Medical University of South Carolina Amendment 3	Solicitation Number	Q191100ADD
		Date Printed	January 3, 2019
		Date Issued	January 3, 2019
		Procurement Officer	Angie DeVeaux
		Phone	843-792-2389
		E-Mail Address	deveauan@muscd.edu

DESCRIPTION: **Fabricate and Install Steel Beam-W8x18**
 USING GOVERNMENTAL UNIT: Medical University of South Carolina

Questions and Answers:

MUSC CHP 1ST FLOOR FOLDING PARTITION
DOOR (ROOM 105)

§202

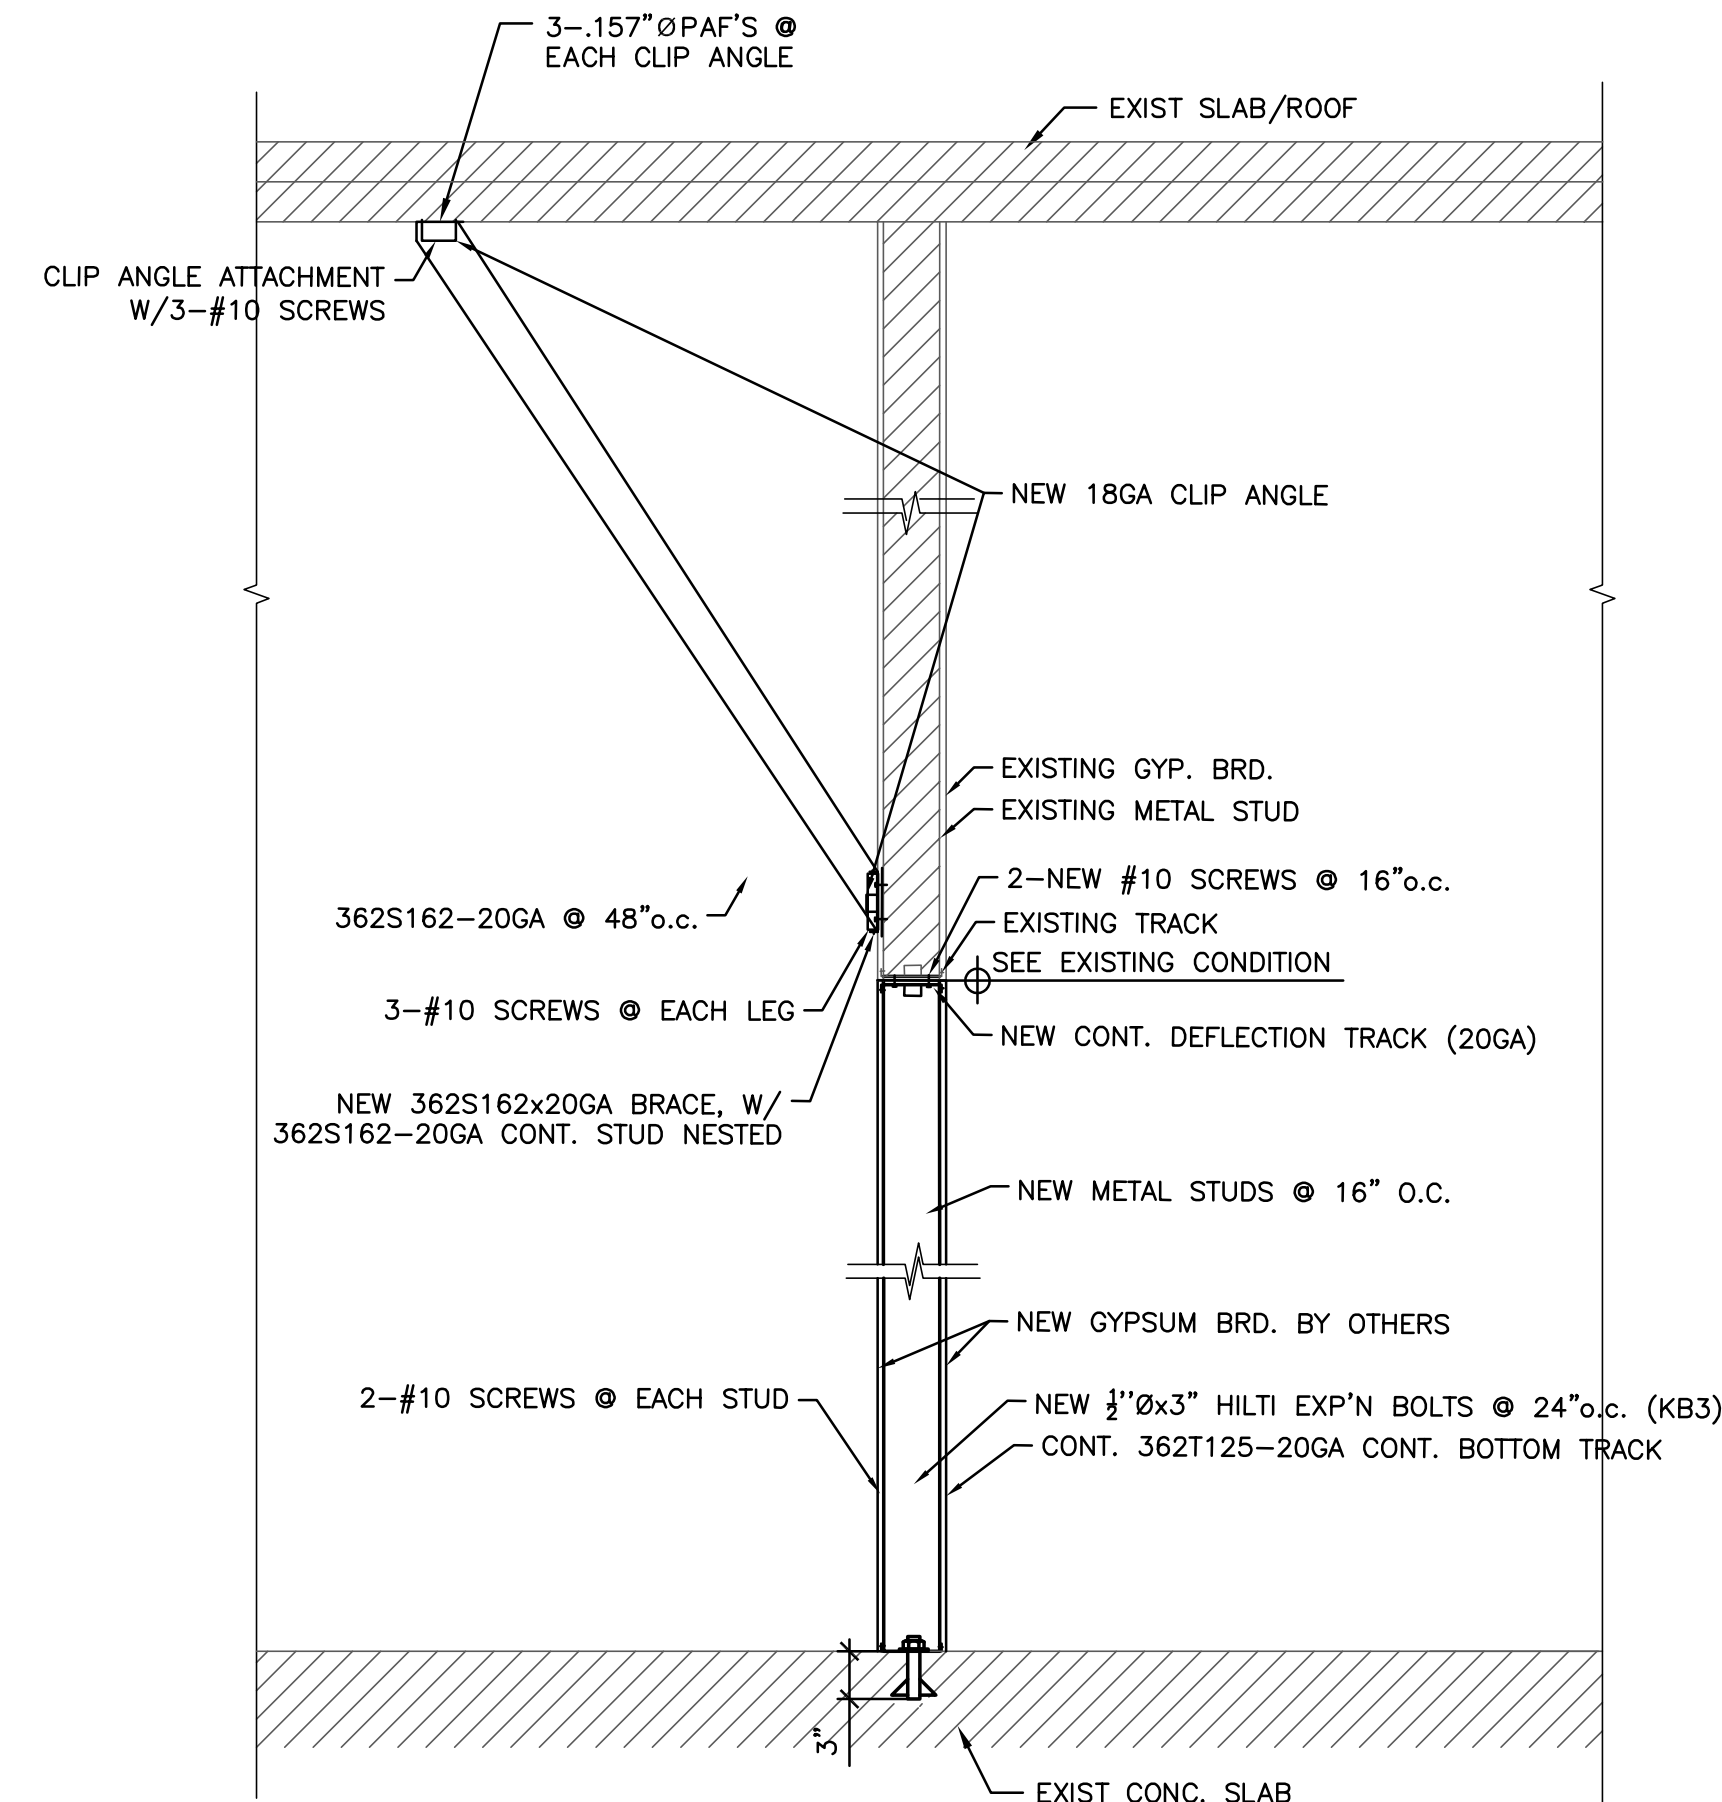
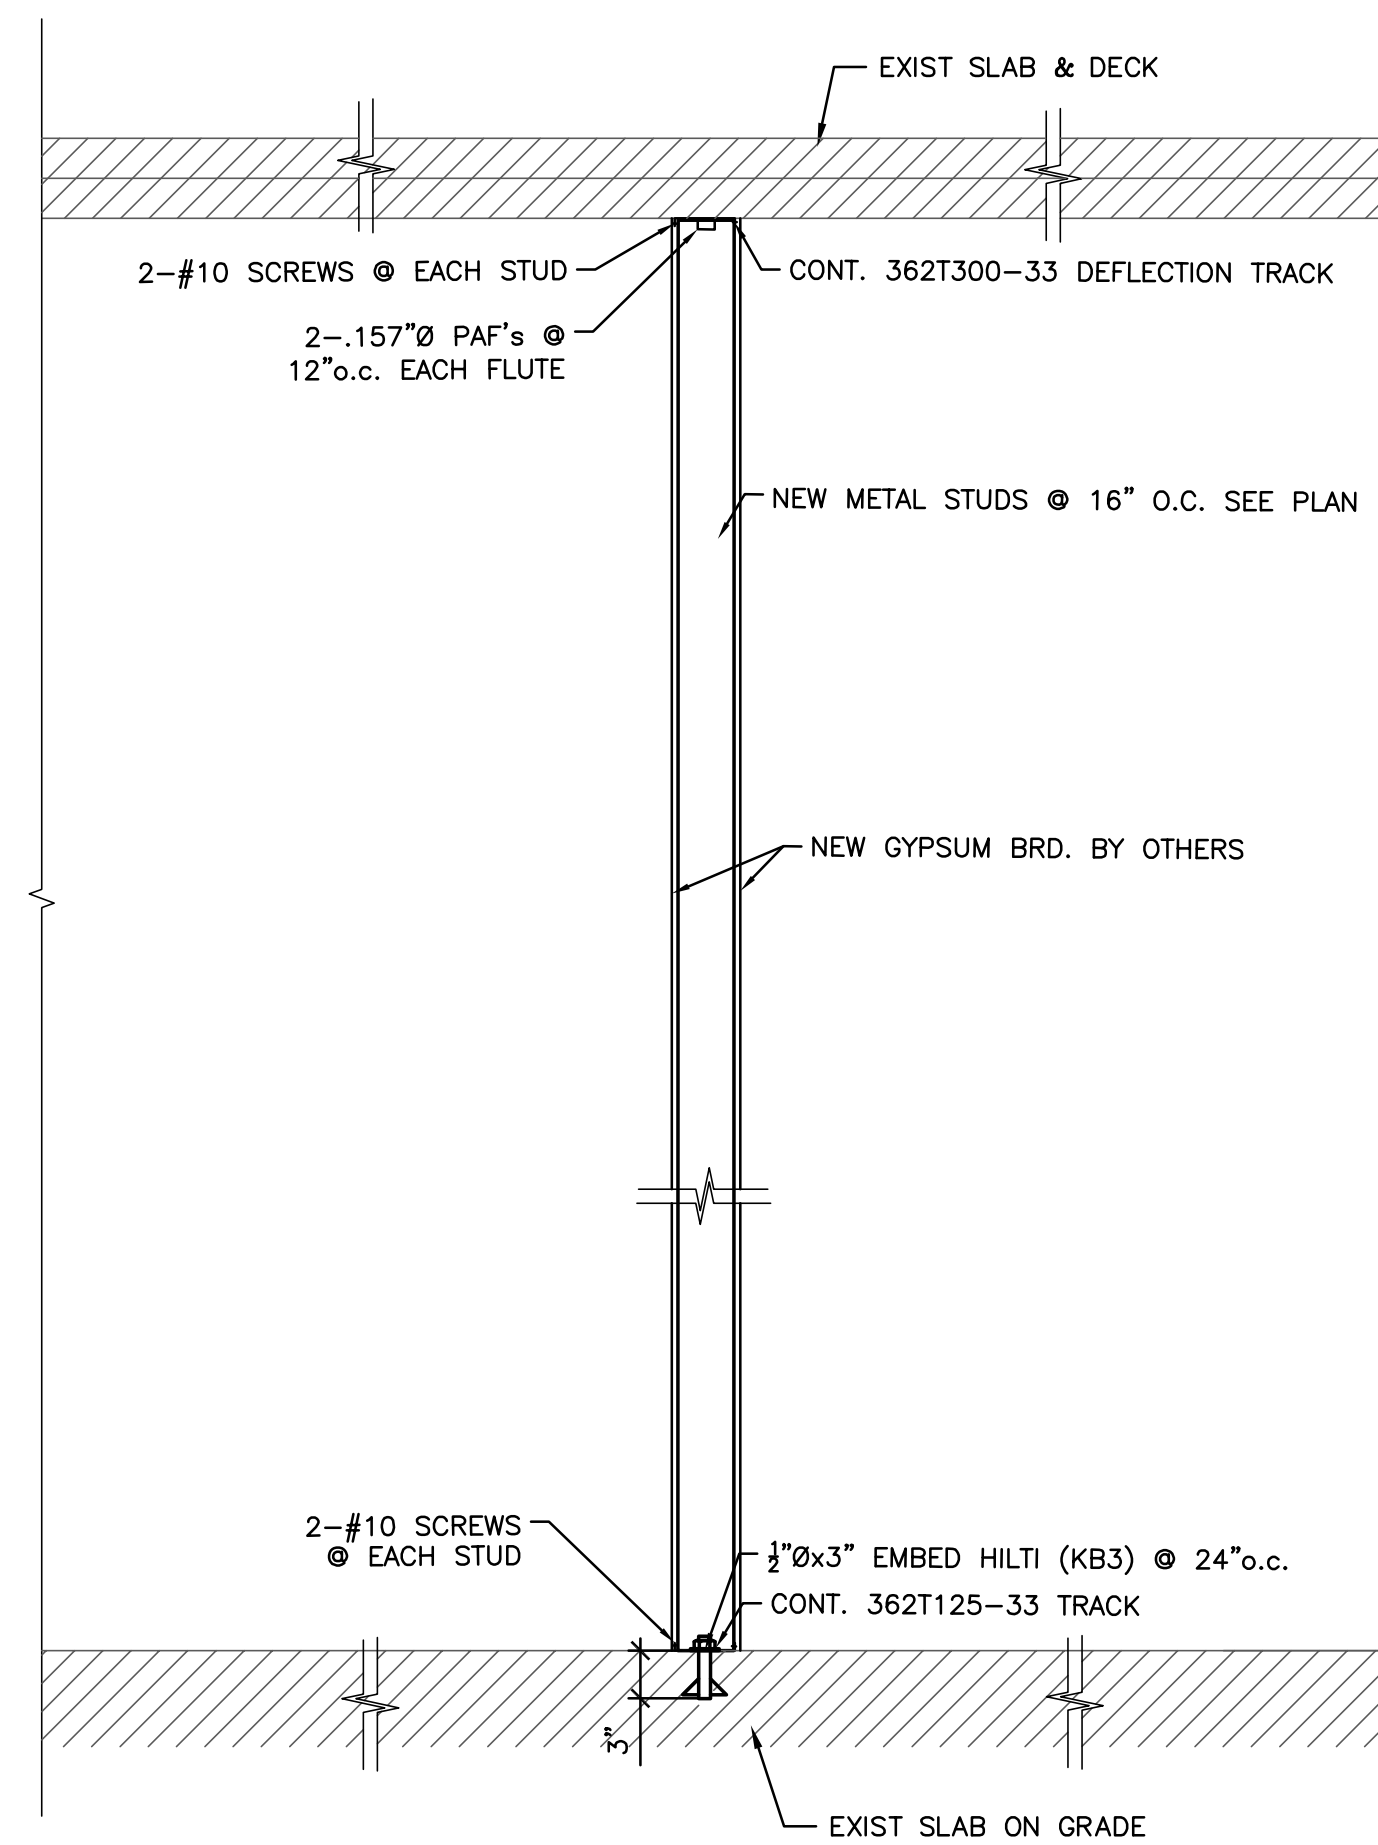
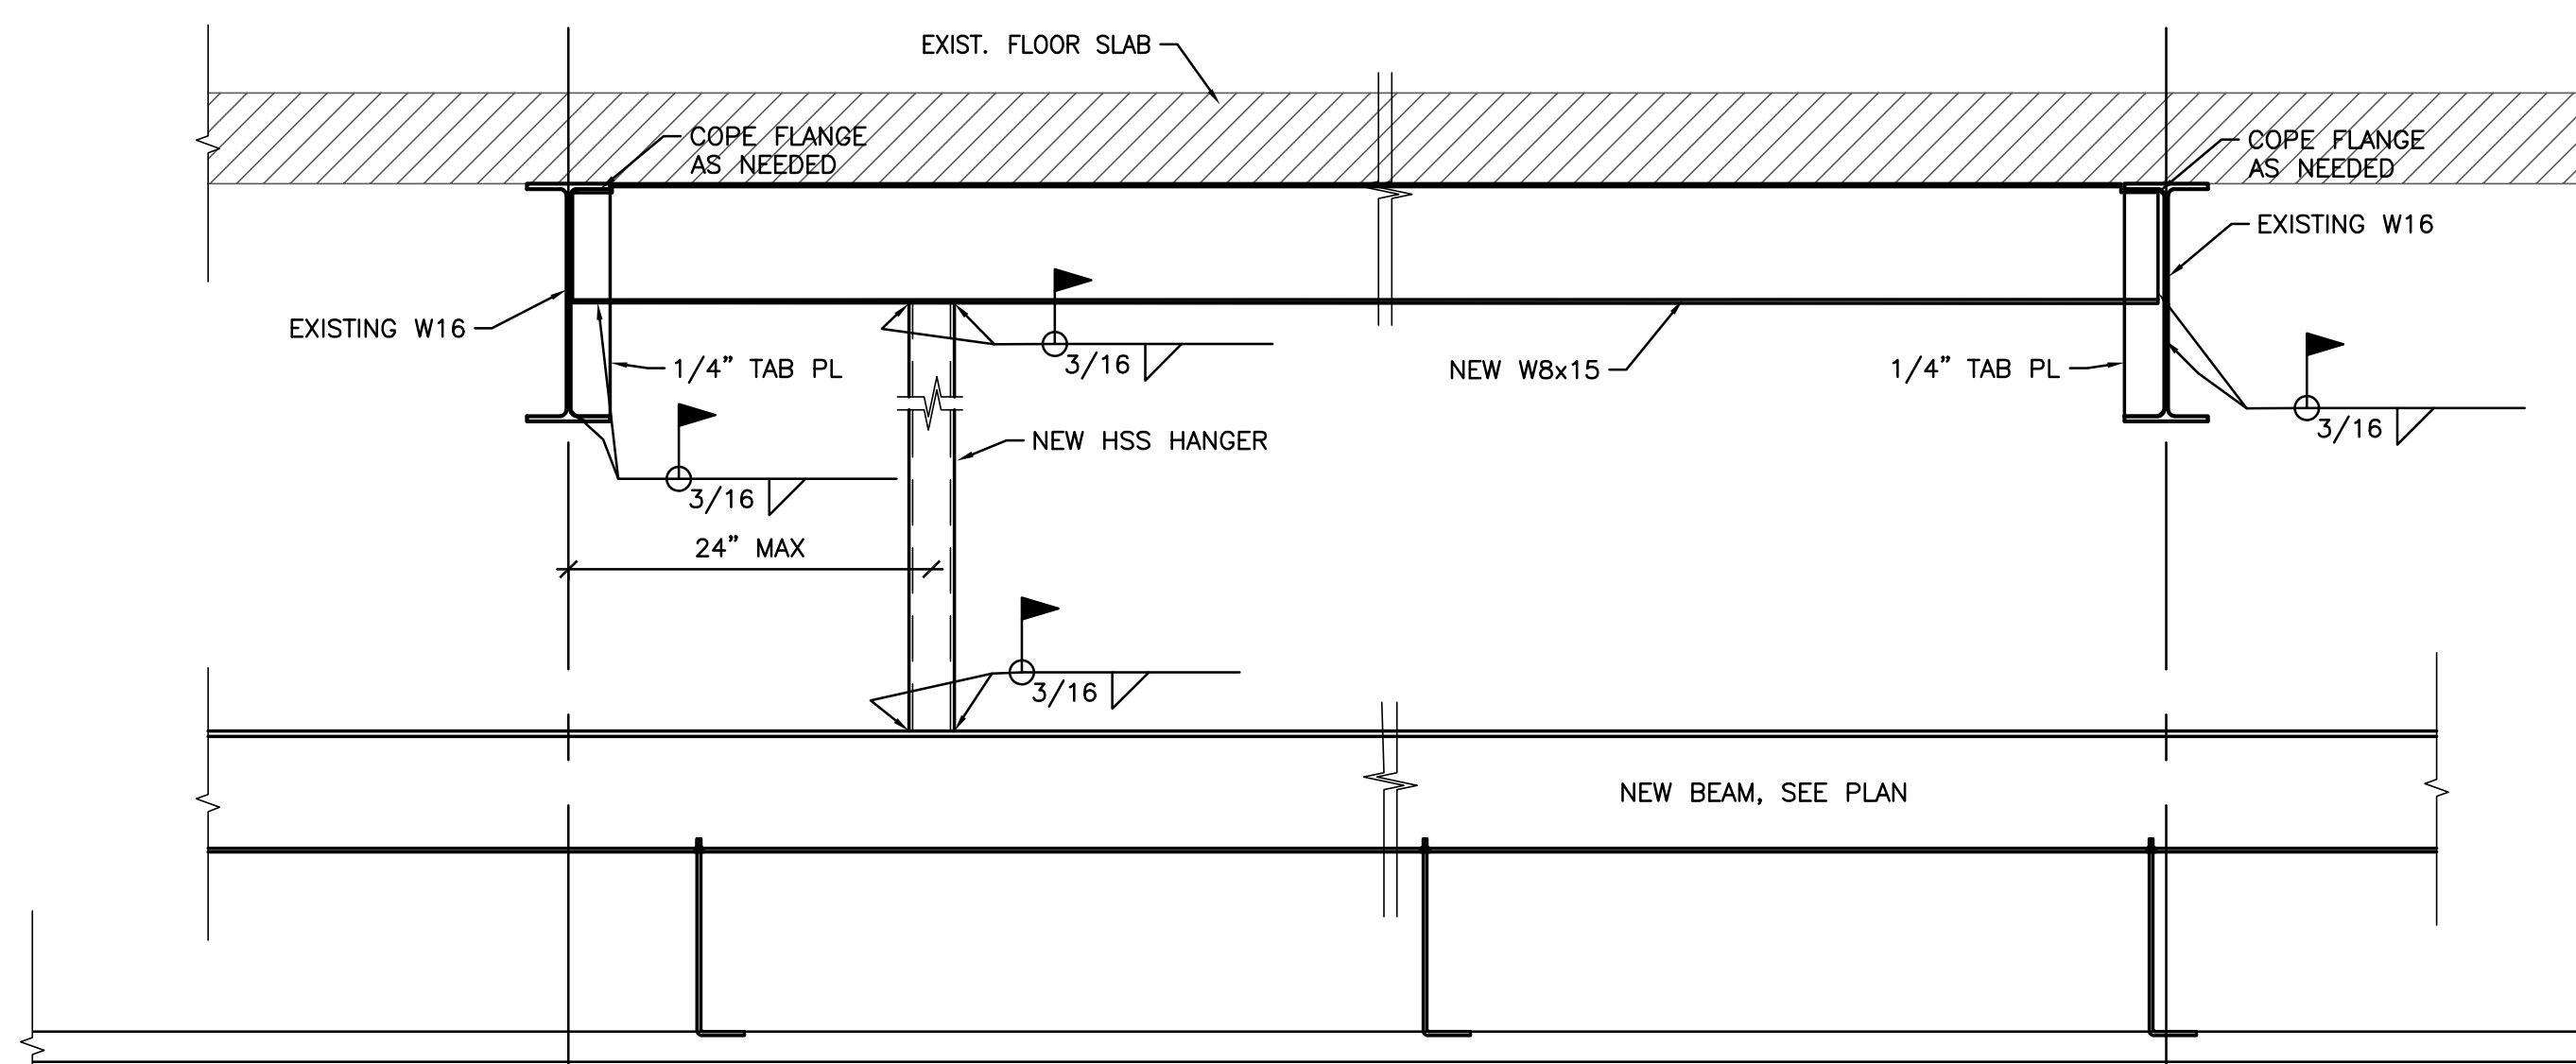
3. If the beam doesn't fist directly underneath the existing beam is there an alternate detail for he hanger?

See attached updated drawing revised 01/17/2019

- **S201 sheet 3 and S202 sheet 4 revised 01/17/2019 alternatives on hangers**
- **S201 sheet 3 revised 01/17/2019 for splice instructions**

3 ALTERNATE POST TO EXISTING STRUCTURE ATTACHMENT DETAIL
